Addendum 110: Regulation No. 111

Erratum

**UNIFORM PROVISIONS CONCERNING THE APPROVAL OF TANK VEHICLES
OF CATEGORIES N AND O WITH REGARD TO ROLLOVER STABILITY**

Figure 1: Cross-section of a tank vehicle

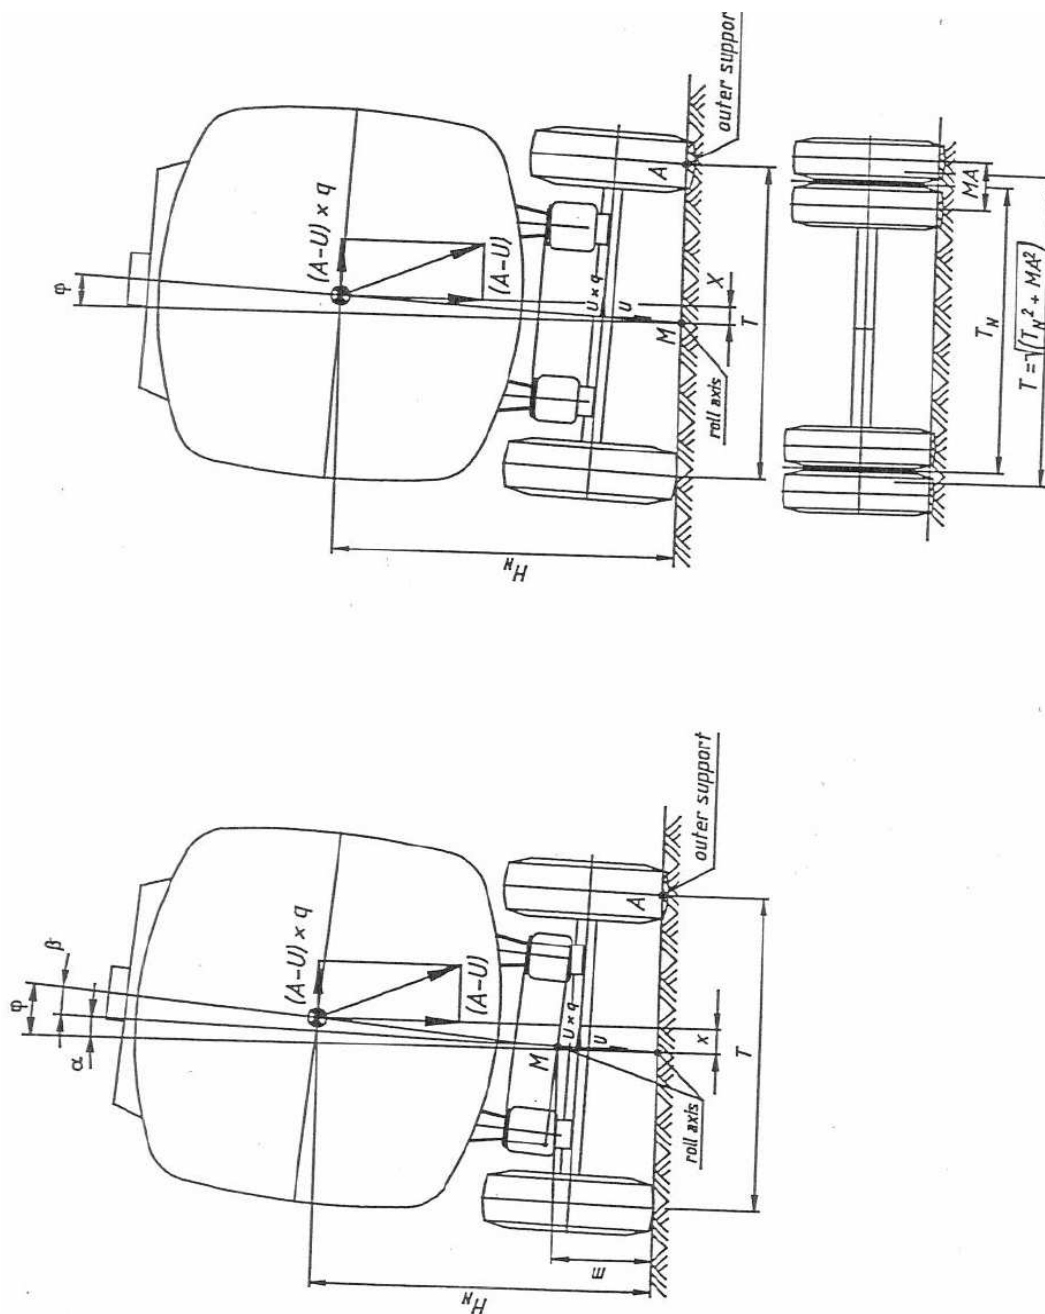
Figure 1, correct to read:
